Applicant : Chi Fung Cheng  
Serial No. : 10/802,597  
Filed : March 16, 2004  
Page : 14 of 18

Amendments to the Drawings:

## HIGH BANDWIDTH PHASE LOCK LOOP

FIG. \_ 6

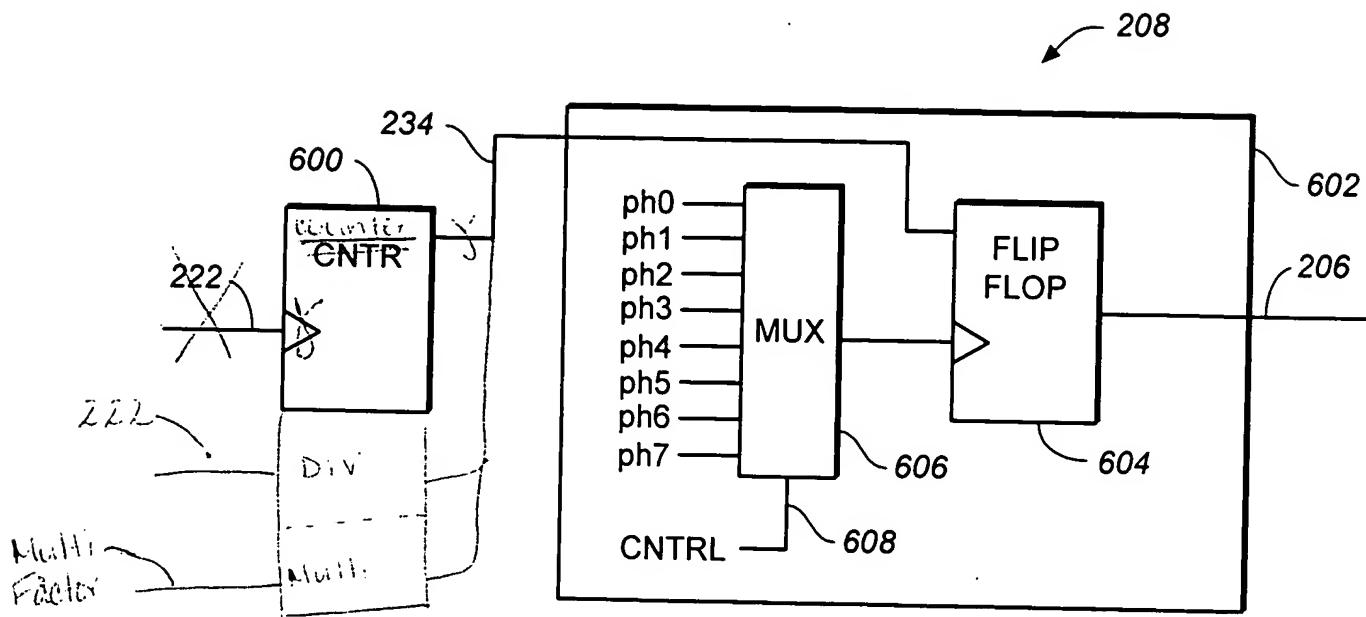
The attached replacement sheet of drawings includes changes to Figure 6 and replaces the original sheet including Figure 6.

In Figure 6, Applicant has amended revised the counter 600 to show elements included therein that are discussed in the specification. No new matter has been added.

The drawings were objected to by the Examiner under 37 CFR 1.83(b). Applicant respectfully traverses the rejection. A substitute drawing sheet adding detail to Figure 6 is attached hereto. No new matter has been added. Support for the noted modifications can be found at least at page 13. lines 1-14. Specifically, the counter 600 supports both multiplication and division functions, outputting signals in support of both operations to flip flop 604.
